RESOLUTION SETTING HEARINGS ON REQUESTS FROM ILEX GROUP, LLC, ON DEVELOPER-INITIATED APPLICATION TO AMEND PLAN THE EXISTING PLANDSM: CREATING OUR TOMORROW PLAN FUTURE LAND USE DESIGNATION AND ON DEVELOPER-INITIATED REQUEST FOR REVIEW AND APPROVAL OF A PROPOSED 1<sup>ST</sup> AMENDMENT TO THE NORTHRIDGE PUD CONCEPTUAL PLAN FOR PROPERTY LOCATED IN THE VICINITY OF 4600 AND 4700 EAST 14<sup>TH</sup> STREET TO ALLOW REVISION FROM A REGIONAL SHOPPING MALL TO A WAREHOUSE AND DISTRIBUTION CENTER

### ZON2020-00018 (4600 AND 4700 EAST 14TH STREET)

# ILEX NORTHRIDGE INDUSTRIAL PUD

SIGNAGE PLAN

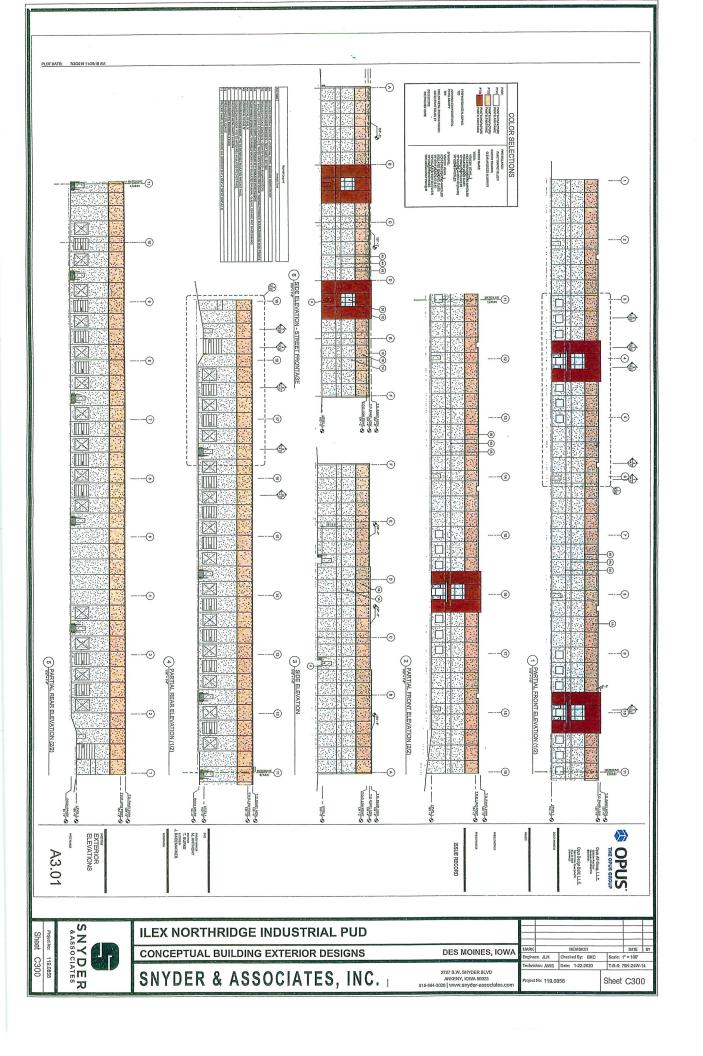
5. Provision of dimensions for the tenant wall sign typicals on Sheet 5 of the Conceptual Plan to the satisfaction of the Planning Administrator.
